BUILDING 1 - FIRST FLOOR DEMOLITION PLAN

Abestos Abatement of Building 1
VA Medical Center
Iowa City

DATE	March 26, 2014
SCALE	
DRAWN	EAS
APPROVED	DRH
FIELD BOOK	
REFERENCE DRAWING	1-AS1
REVISION	Addendum 1

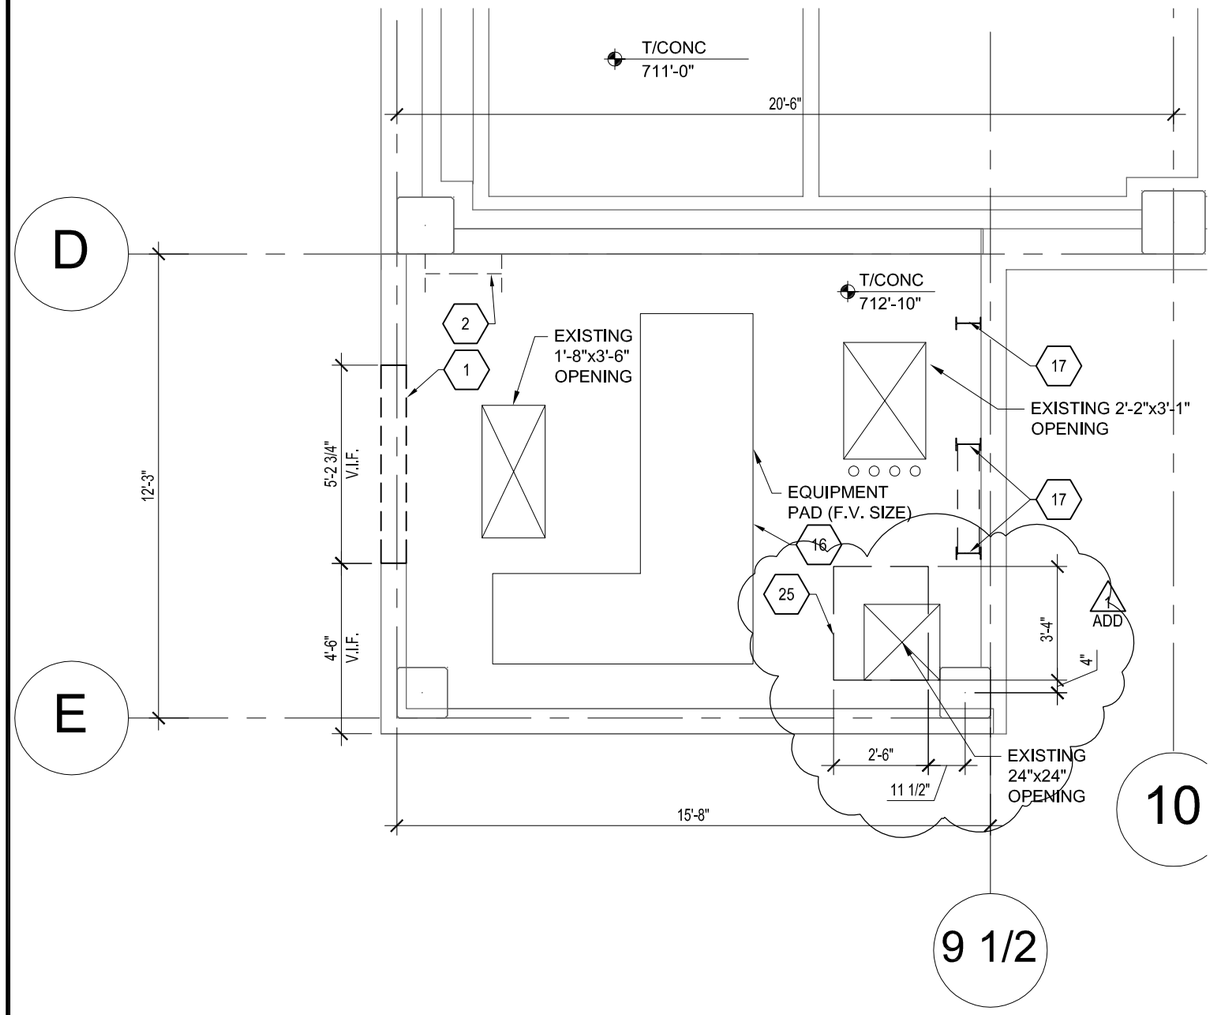
25. REMOVE CONCRETE SLAB TO THE EXTENTS SHOWN. 1 ADD
